## Quality Assurance of Chapter 9: Definition of the Beltline

This report documents the results of the quality assurance task for Chapter 9 of the draft technical basis NUREG for the risk-informed Appendix G project. Chapter 9 discusses a more precise definition for the term "beltline." The quality assurance effort for this chapter involved three specific subtasks: (1) plotting axial fluence profiles for several reactor vessels, (2) verifying reference temperature shift calculations, and (3) verifying a check of the Reactor Vessel Integrity Database (RVID2) with license renewal application (LRA) data.

Figure 1: Axial fluence profiles for 3 BWR vessels, as determined during the QA work.

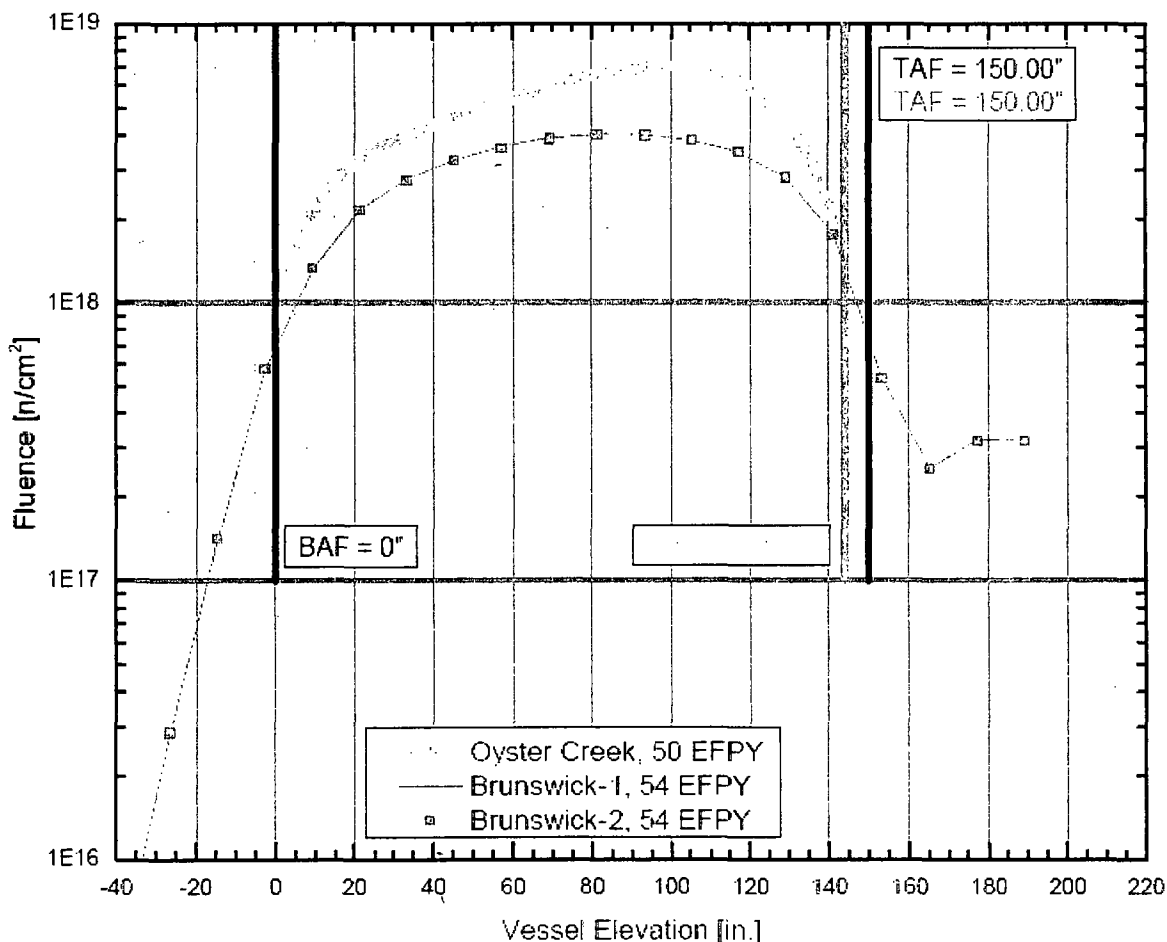
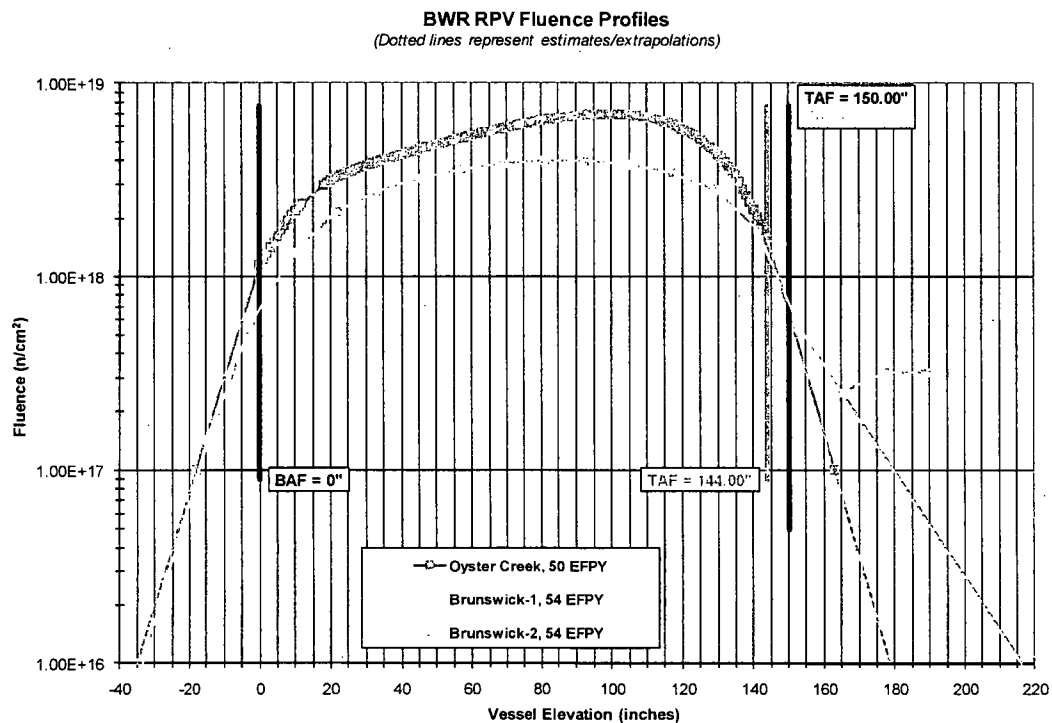
The fluence data was independently extracted from the sources used in the technical basis work. The boiling water reactor (BWR) fluence profiles obtained during the quality assurance (QA) work are shown in Figure 1, while the plots obtained during the technical basis (TB) work are shown in Figure 2. The corresponding plots for pressurized water reactors (PWRs) are shown in Figures 3 and 4, respectively. The figures show reasonable agreement.

Figure 5: Comparison of  $\Delta T_{30}$  calculations using two sets of input data, as determined during the QA work.

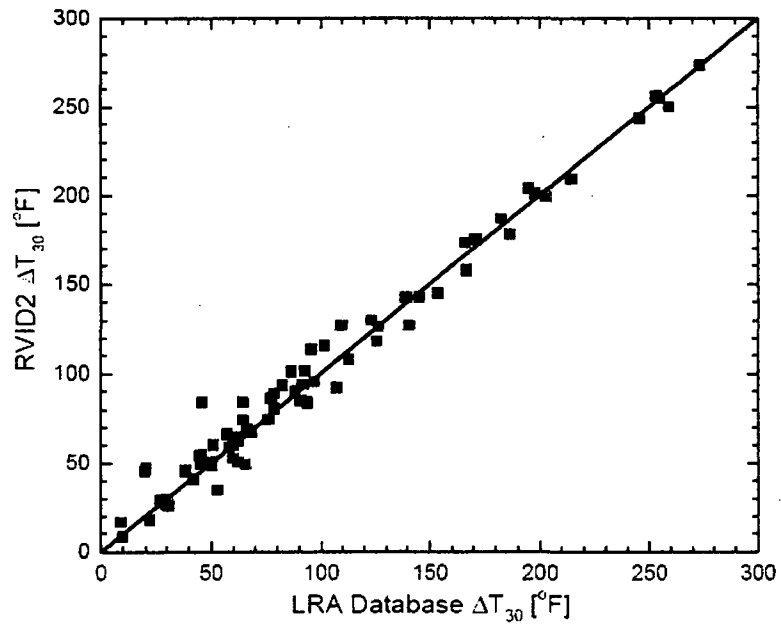
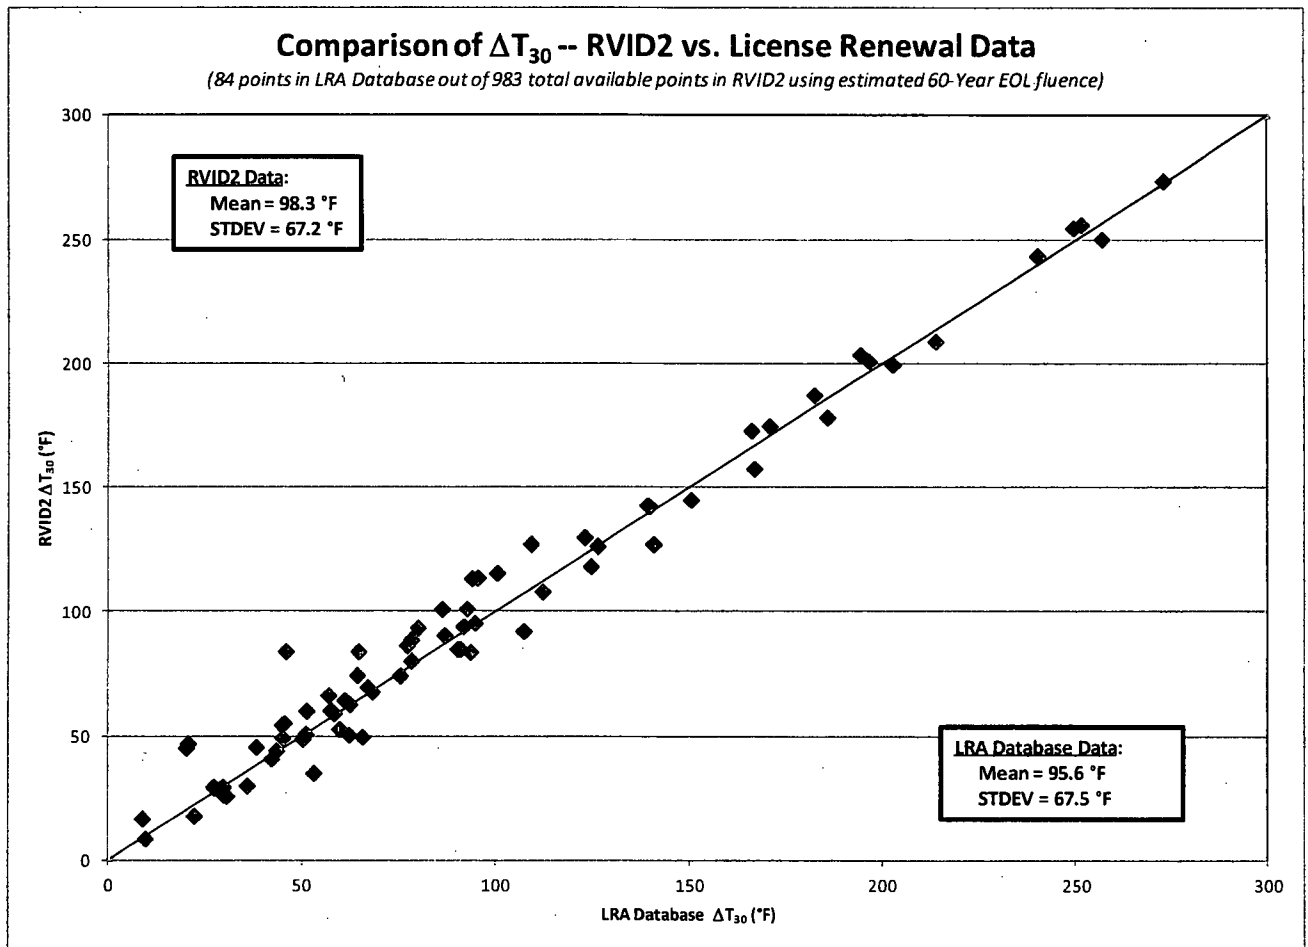
Qualitatively, Figures 5 and 6 show reasonable agreement.
